<p style="text-align: center;"> <small>• MANUFACTURERS OF WIPLINE FLOATS & SKIS • SPECIALISTS IN AIRCRAFT MODIFICATION</small> </p> <p style="text-align: center;"> <small>1700 Henry Avenue - Fleming Field South St. Paul, MN 55075 651-451-1205</small> </p>			Rev A.1
			Date 3/22/2007 Reissued: 3/13/2026
Prepared by Ryan Nordell	Aircraft Make / Model AT-802	Float / Ski Model Wipline Model 10000 Amphibious	Page 1 4
FAA Reviewed <input checked="" type="checkbox"/>	Title AT-802 Asymmetric Scoop Position Indicator Upgrade		
ALL INFORMATION IN THIS SERVICE DOCUMENT BASED ON FAA APPROVED DATA

SERVICE KIT: 71

EFFECTIVITY: AT-802 aircraft with Wipline Model 10000 floats S/N 10003 to 10052

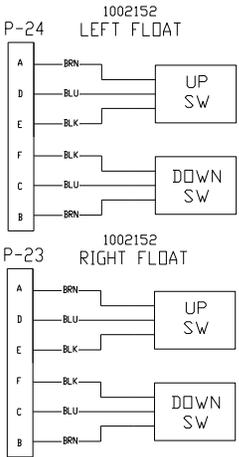
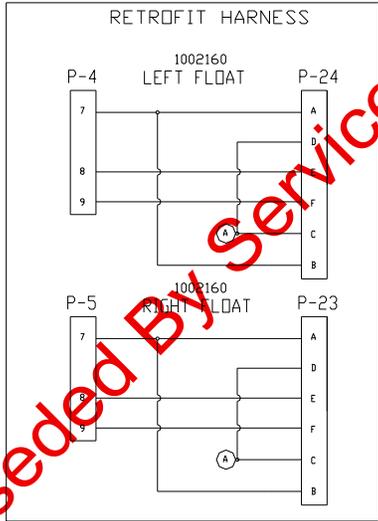
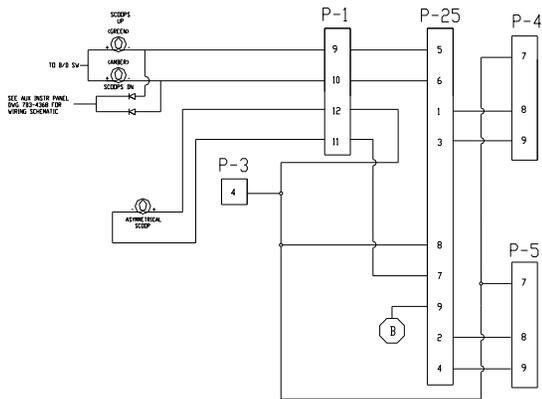
11. Insert pins into 7, 8 and 9 on plug P4 & P5 per drawing 1002265.
12. Actuate the probes to check proper positioning of the magnetic switches and adjust the position of the switches if needed.
13. Reinstall and seal all covers removed in step 1 and reinstall foam tank.
14. Repeat steps 1-12 for other float.
